**RESOLUTION CLOSING PUBLIC HEARING AND APPROVING THE PROPOSED
AMENDMENT TO THE RIVER OAKS CENTRE "PUD" CONCEPTUAL PLAN**

Request from Conlin Equities, LLC. (owner) represented by James Conlin (officer) for property located at 6000 Creston Avenue.		File #			
		ZON2007-00055			
Description of Action	PUD amendment to the River Oaks Centre Conceptual Plan to allow for development of Lot 6 to have an increase from 72 to 120 multiple-family units configured in five (5) three-story 24-unit buildings.				
2020 Community Character Plan	Medium-Density Residential				
Horizon 2025 Transportation Plan	No Planned Improvements				
Current Zoning District	"PUD" Planned Unit Development				
Proposed Zoning District	"PUD" Planned Unit Development				
Consent Card Responses	In Favor	Not In Favor	Undetermined	% Opposition	
Inside Area					
Outside Area	1	33	0	<20%	
Plan and Zoning Commission Action	Approval	10-1	Required 6/7 Vote of the City Council due to a recommendation for DENIAL by the Commission	Yes	X
	Denial			No

River Oaks Center PUD - 6000 Creston Avenue

ZON2007-00055

Job No. 081246
Date 06.11.07
Sheet No. A3
Title DEER RIDGE APARTMENTS
EXTERIOR ELEVATIONS
Scale 1/8" = 1'-0"

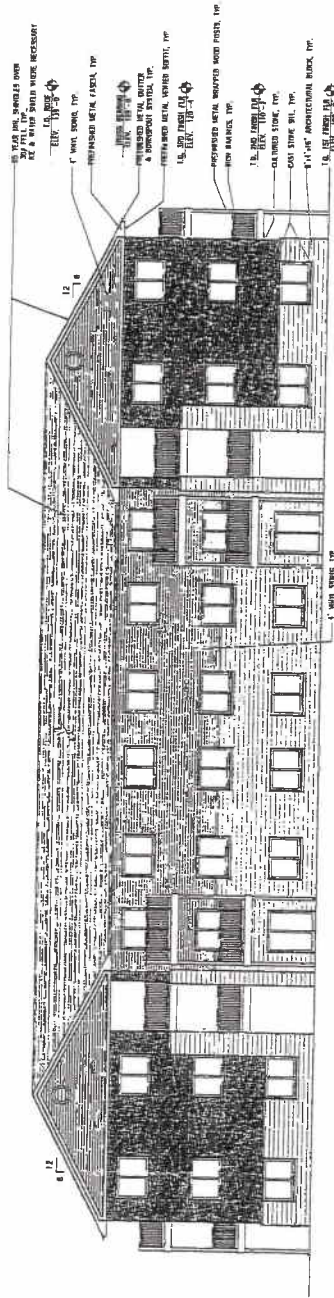
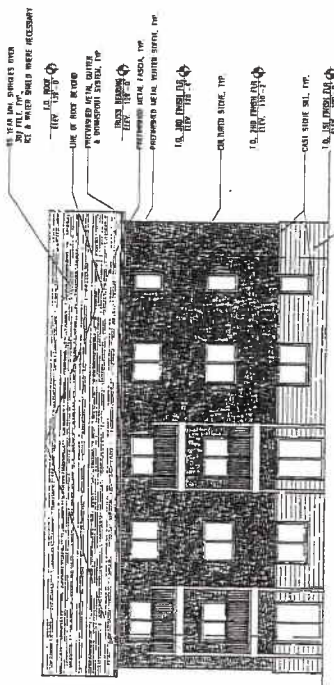
9. **Urban Design:** The submitted elevations provide for five 3-story buildings, each with 24 units. The structures would be constructed with architectural block on the lower portion of the facades. The ends would be cultured stone, with the balance being 4"-exposed vinyl siding. The asphalt-shingled roof would include two gables facing the front of the structure and two gables facing the rear of the structure. The elevations also demonstrate balconies with pre-finished metal wrapped wood posts and irons railings.
